November 17, 2025
Subject: Pleasant Avenue Crossing
Bridge Wearing Surface
Replacement
State WIN: 023120.00
Location: **Dover Foxcroft**
Amendment No. 4

Please make the following changes to the Bid Documents:

STATE OF MAINE DEPARTMENT OF TRANSPORTATION	STP-2312(000)	WIN 023120.00	BRIDGE PLANS 5118
DOVER BRIDGE PISCATAQUIS RIVER DOVER-FOXCROFT PISCATAQUIS COUNTY	GENERAL PLANS		
SHEET NUMBER	4		
OF 64

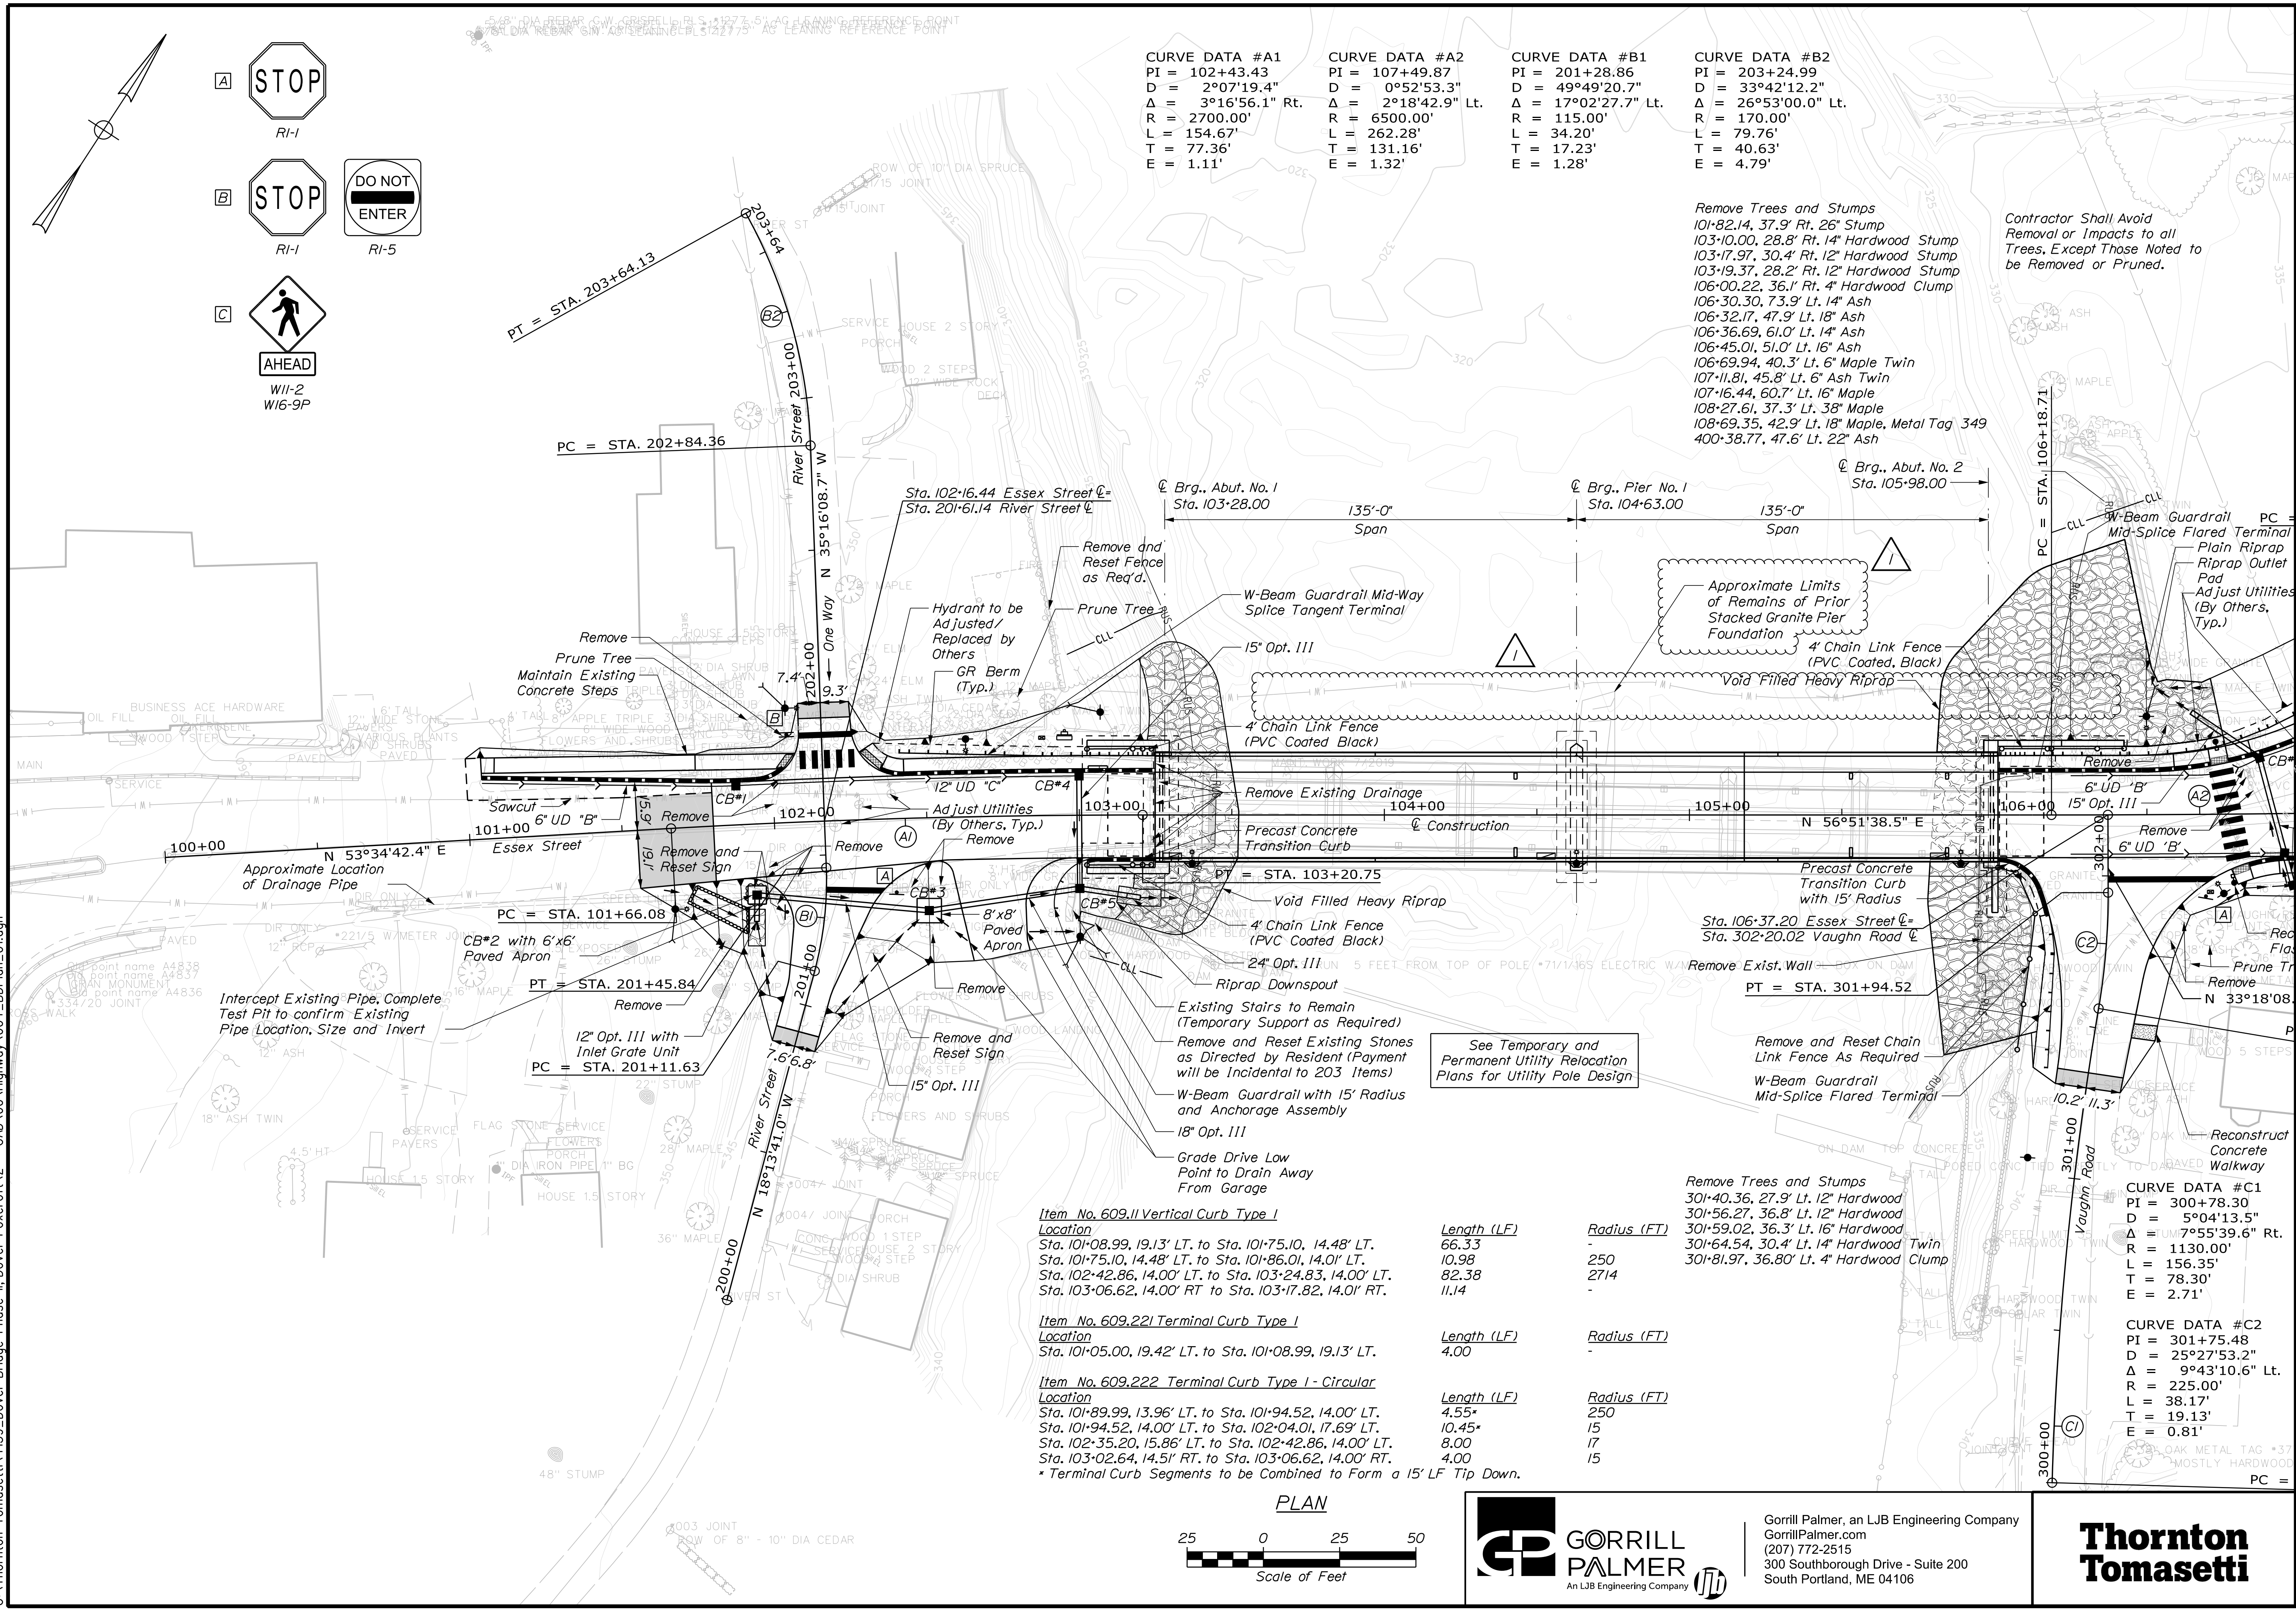
MaineDOT has located the active water main in the riverbed and updated the water main location on plan view on sheet 4 of the plans. The remains of an old pier foundation consisting of cut granite block was also located and is shown on an updated general plan sheet.

GIRDER DETAILS (2 OF 2)

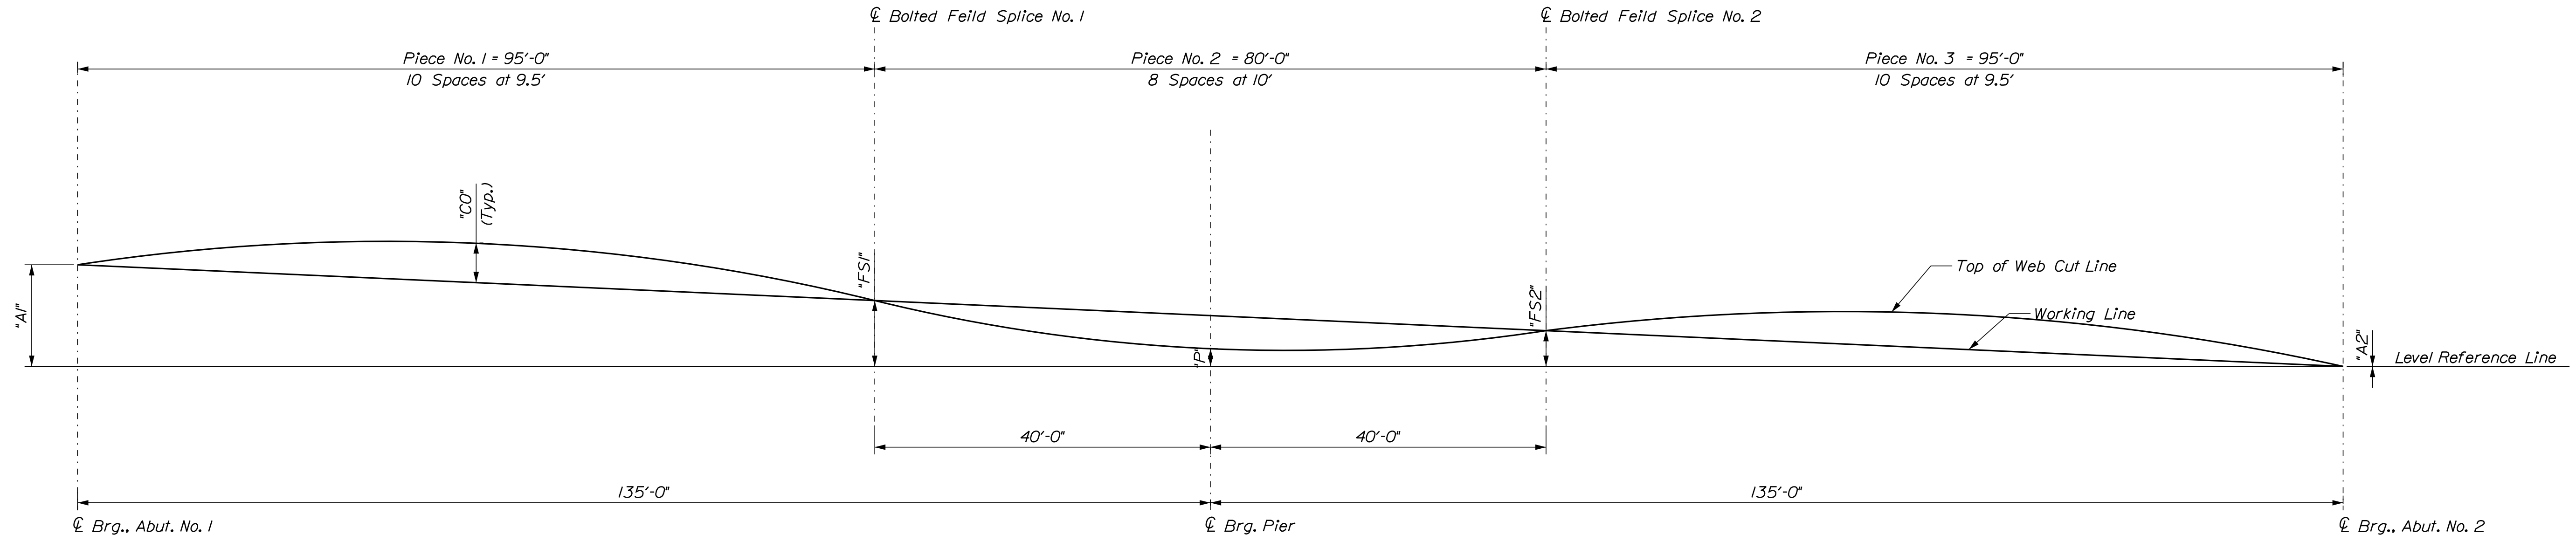
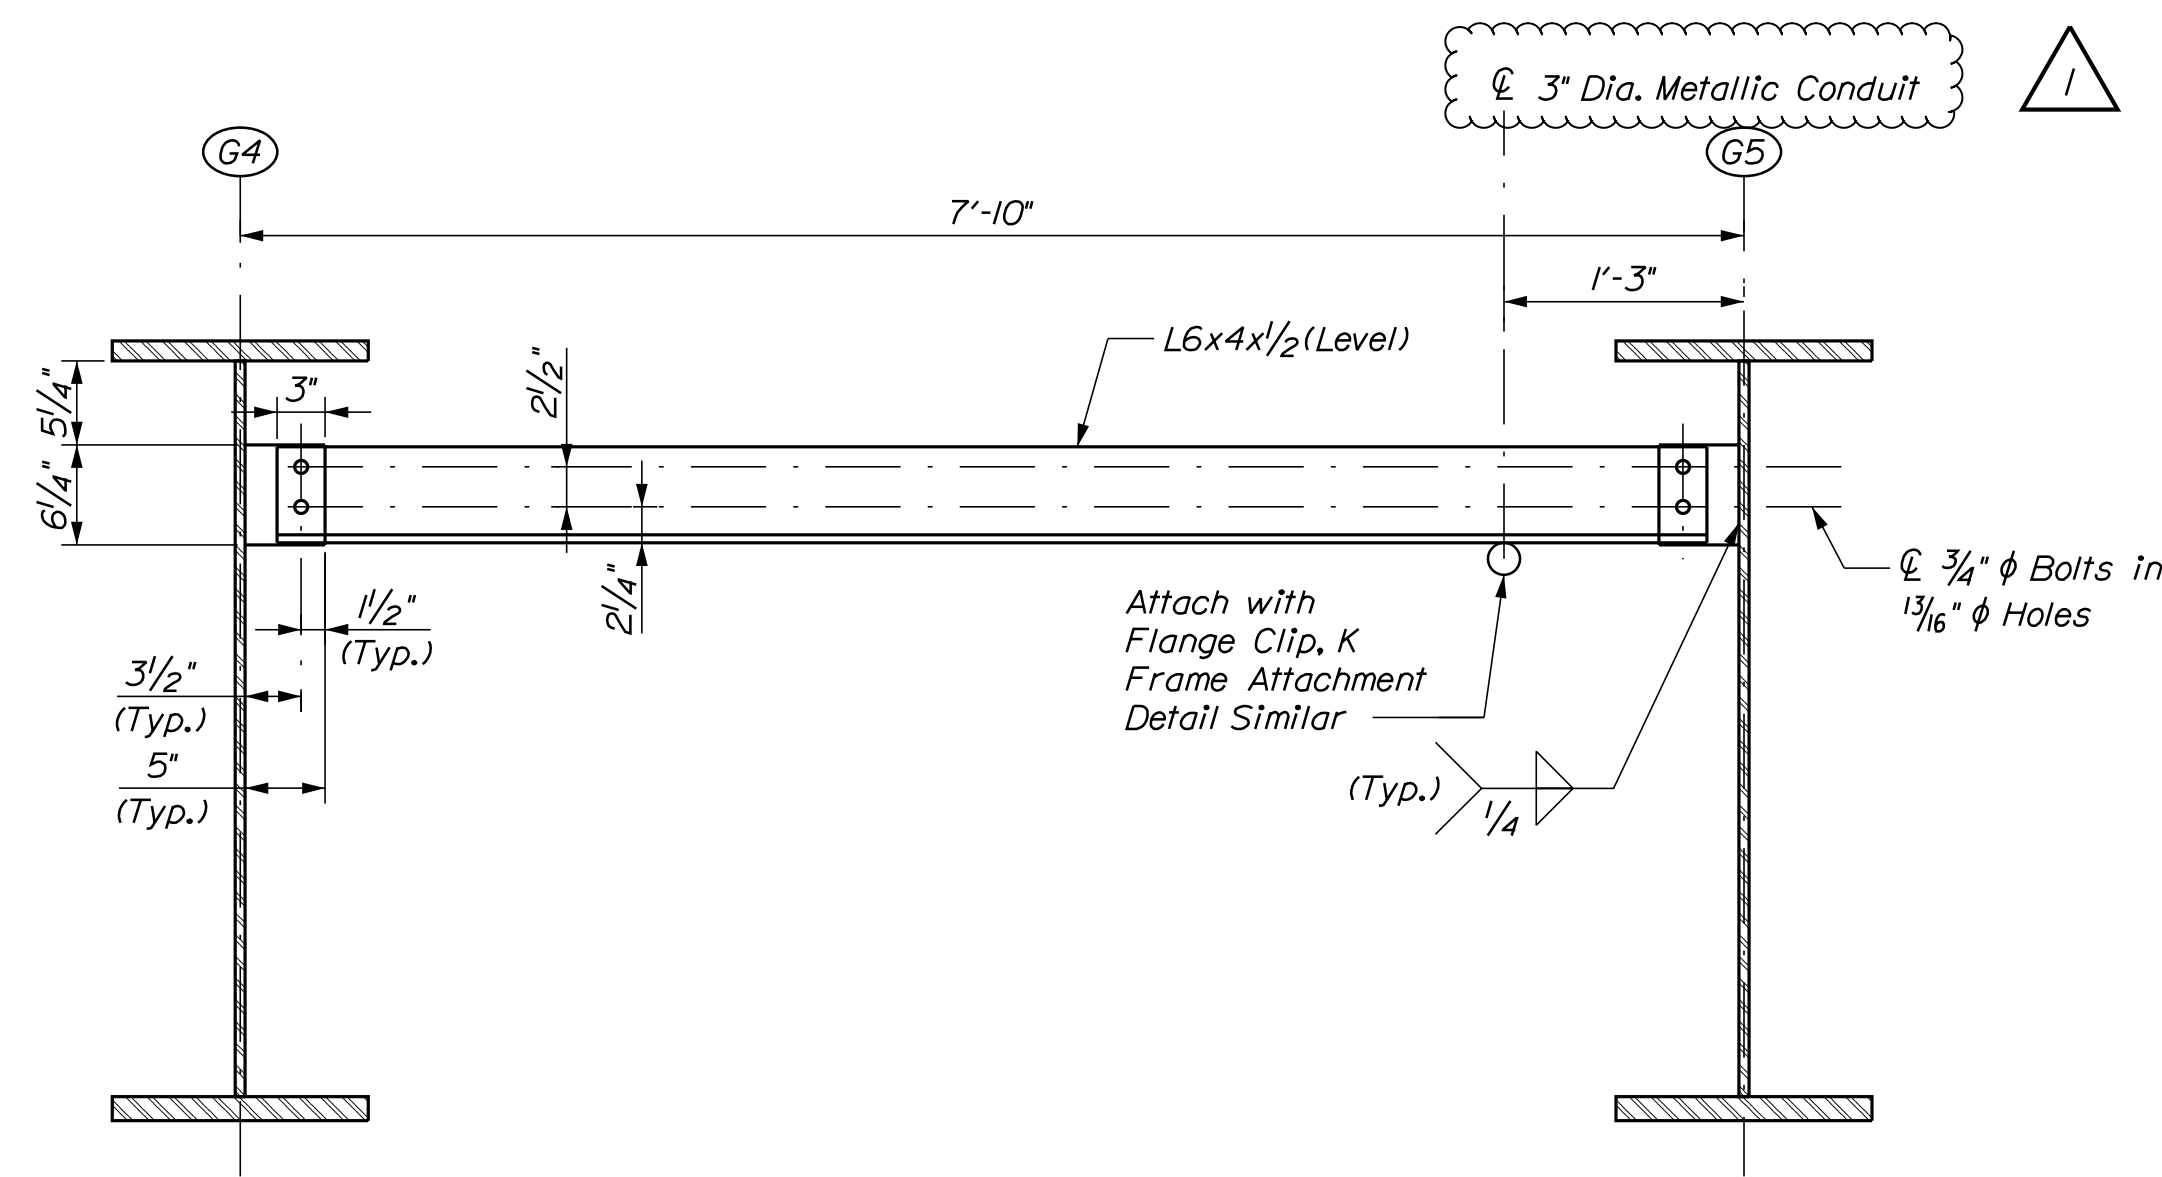
Response: The lighting conduit size noted on sheets 47 and 55 has been changed from 2” diameter to 3” diameter. Please reference the revised sheets 47 and 55. The conduit will be supported under the bridge by Utility Support Type T2 as indicated on sheet 47. Type T2 support shall be installed between G4 and G5 as shown on the framing plan on sheet 45.
